ADDENDUM NO. 2

RE: **Athletic Performance Addition**
Perkinston Campus, MGCCC
Perkinston, Mississippi
A/E Project No. 26-028a

FROM: EGH Architects
1091 Tommy Munro Drive
Biloxi, MS 39532
(228) 594-2323

2 MEZZANINE HVAC PLAN DETAIL
3/8" = 1'-0"

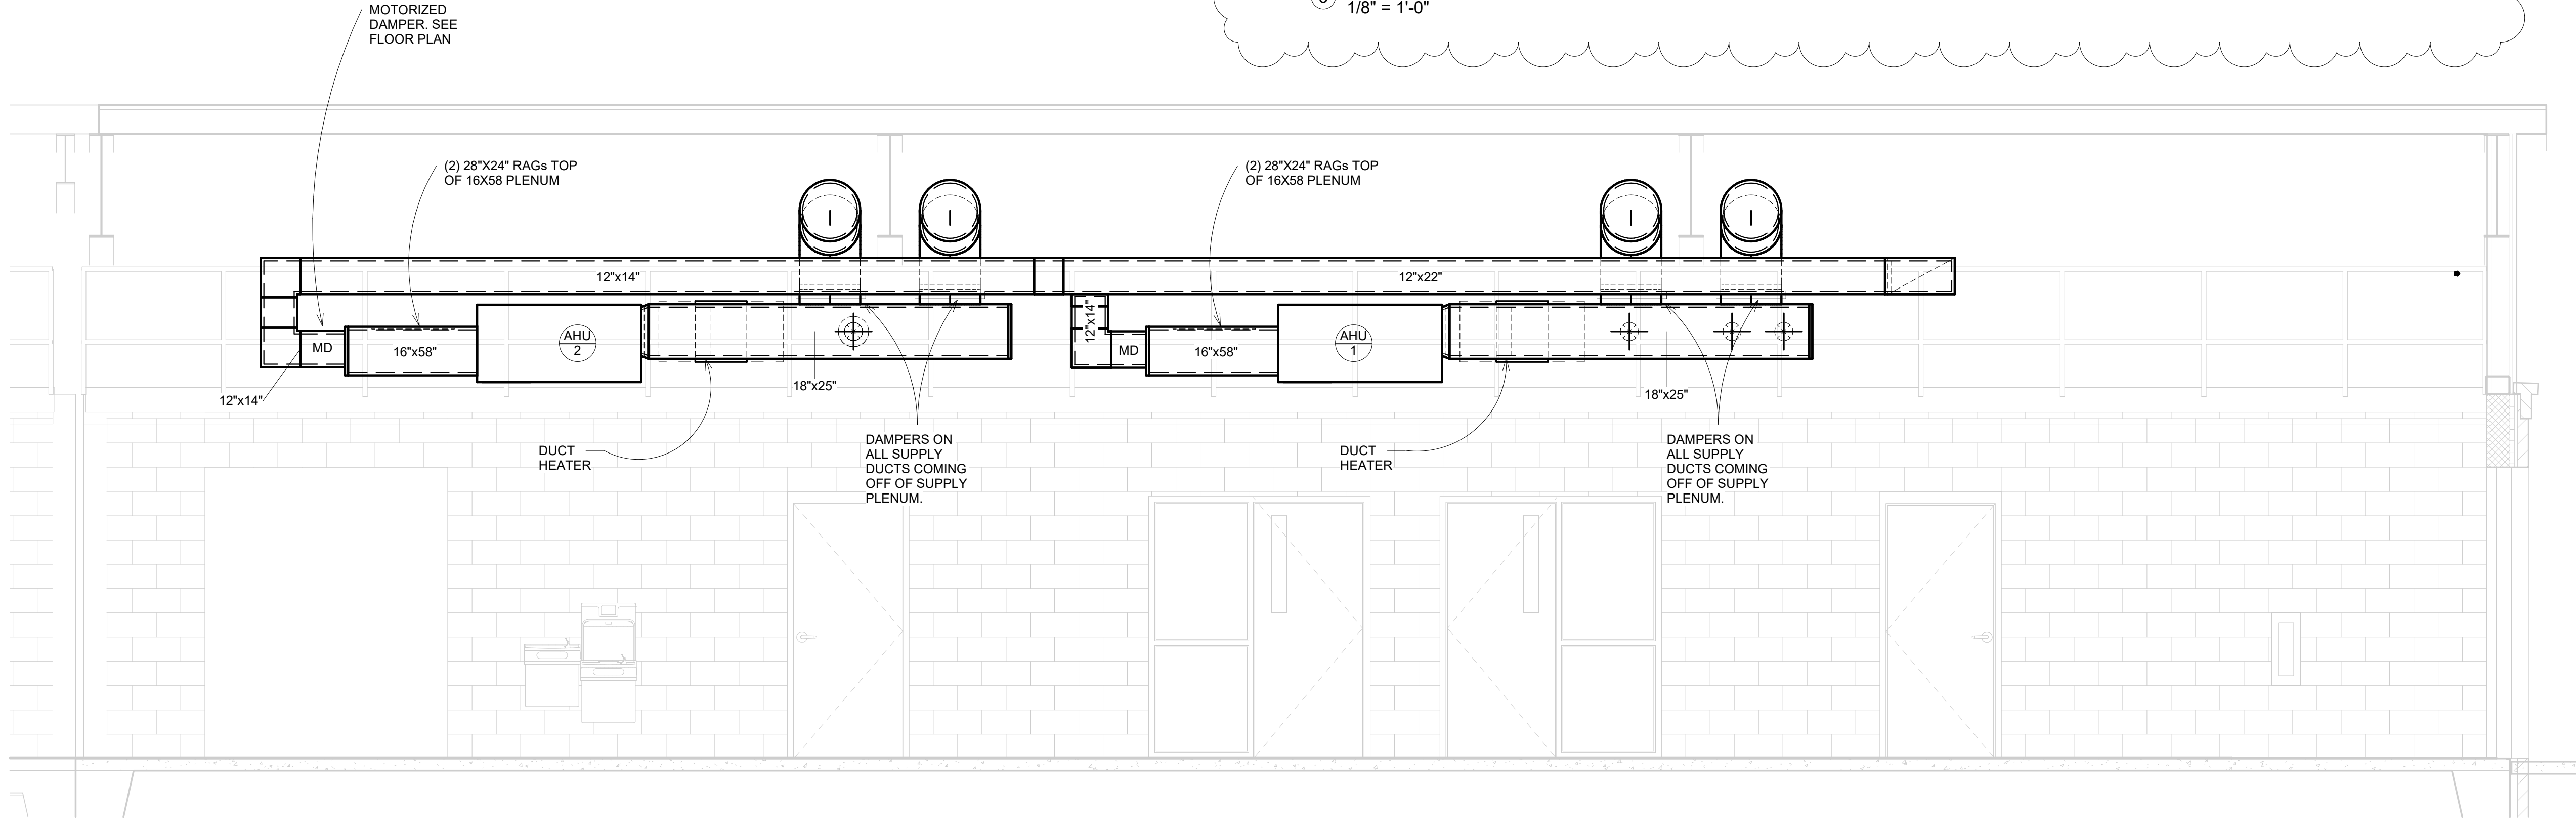
- Refrigerant lines shall be routed around the filter and down through the mezzanine floor. Care should be taken to place the refrigerant lines in such a manner that does not obstruct the walking path or service access to the air handling units.
- Added control wiring diagram.
